From: WILLIFORD Dennis (AREVA) [Dennis.Williford@areva.com]
Sent: Thursday, May 26, 2011 8:58 AM
To: Tesfaye, Getachew
Cc: BENNETT Kathy (AREVA); DELANO Karen (AREVA); ROMINE Judy (AREVA); RYAN Tom (AREVA); HAMMOND Philip (AREVA)
Subject: Response to U.S. EPR Design Certification Application RAI No. 458, FSAR Ch. 3, Supplement 3
Attachments: RAI 458 Supplement 3 Response US EPR DC.pdf

Request for Additional Information No. 458, Supplement 3

U.S. EPR Standard Design Certification

Docket No. 52-020

Figure 03.09.01-14-1—Temperature Profile along the Pipe-Cross Section at Mid-Thickness (Case 1)

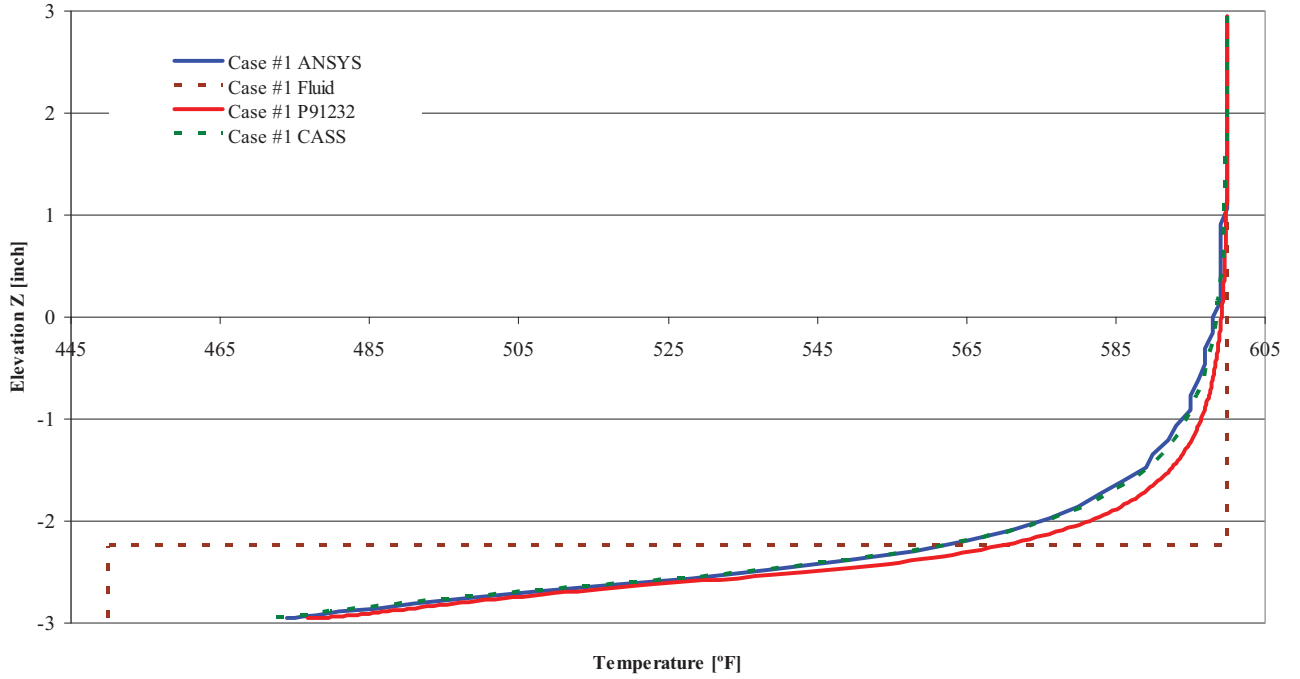
The staff noted that the AREVA methodology developed to calculate the temperature profile on pipe cross-section (@ mid-thickness) should be verified and benchmarked by a computer program which is recognized in the public domain and has had sufficient history of use to justify its applicability and validity (e.g. ANSYS). The staff requests AREVA to provide the benchmark comparison.

- a) AREVA NP has benchmarked the thermal stratification functionality of the internally developed program P91232 with a commercially available finite element computer code, ANSYS R12.1. The benchmarking methodology consists of comparing the results from ANSYS with results from P91232 and CASS. P91232 is currently benchmarked to CASS in the calculation in this question.

The benchmarking comparison shows the temperature profile along the pipe cross section at mid-thickness. The two loading cases benchmarked are the same as the two loading cases documented in the AREVA NP calculation, reviewed by the NRC staff during their onsite audit. The comparison between the results from P91232, CASS, and ANSYS is performed by plotting the results on one graph for each loading case, as shown in Figure 03.09.01-14-1 and Figure 03.09.01-14-2.

The results comparison between ANSYS and P91232 shows good agreement, and P91232 produces reliable results.

Figure 03.09.01-15-1—Comparison of Unbroadened 5% Spectrum

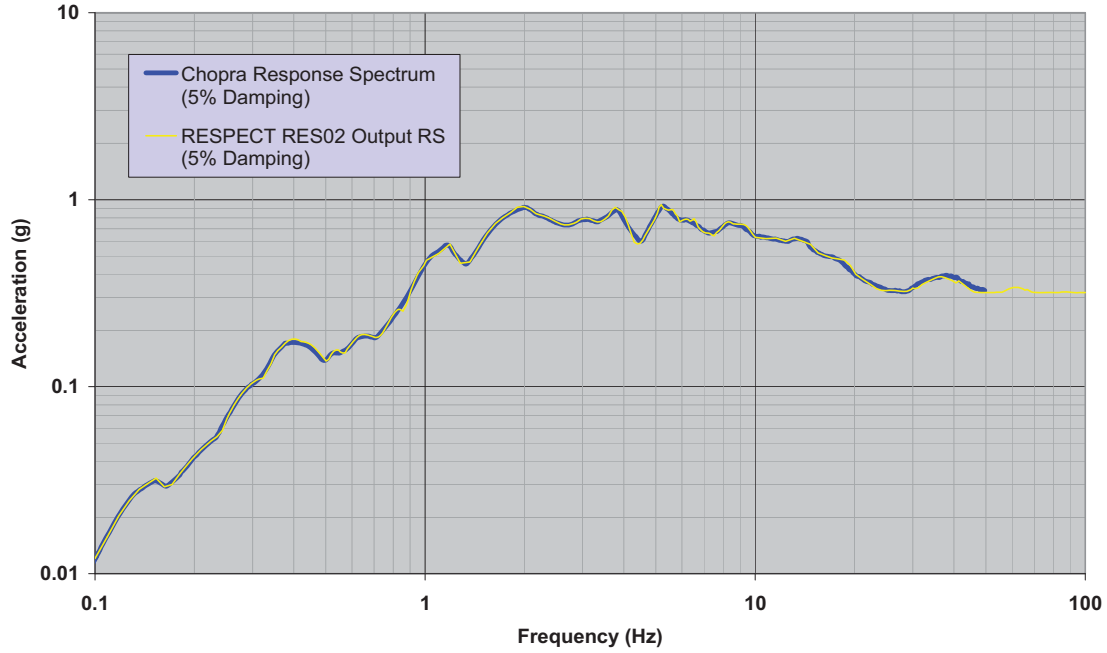
FSAR 3.9.1.2 identified that computer program RESPECT is to be used for EPR design. The staff reviewed the supporting documents for the program RESPECT and noted that the validation is not found for RESPECT computer program that generates response spectrum from an acceleration time history for un-broaden and broaden spectra that will be used in the downstream response spectrum piping analysis. The staff requests AREVA to provide validation for this computer program.

The acceptance criteria for the benchmarking of RESPECT results are obtained from Reference 1, Chapter 6. The benchmark case contained in Reference 1 is the north-south component of the ground motion recorded at a site in El Centro, California during the Imperial Valley, California earthquake of May 18, 1940.

Reference 1, Appendix 6 provides the benchmark input time history. Reference 1, Figure 6.6.4 for damping ratios of 0, 2, 5, 10 and 20 percent show the resultant determined, pseudo-response spectrum acceleration.

The time history from Reference 1, Appendix 6 is input into RESPECT and executed using the same parameters. The output response spectrum plots from Reference 1, Figure 6.6.4 for the 5 percent and 2 percent damping are plotted against the respective RESPECT output response spectrum. The resultant plots are shown in Figure 03.09.01-15-1 and Figure 03.09.01-15-2. The comparison of the un-broadened response spectrum between RESPECT and Reference 1 shows good agreement. Therefore, RESPECT is validated for the functionality of response spectrum generation from a given time history.
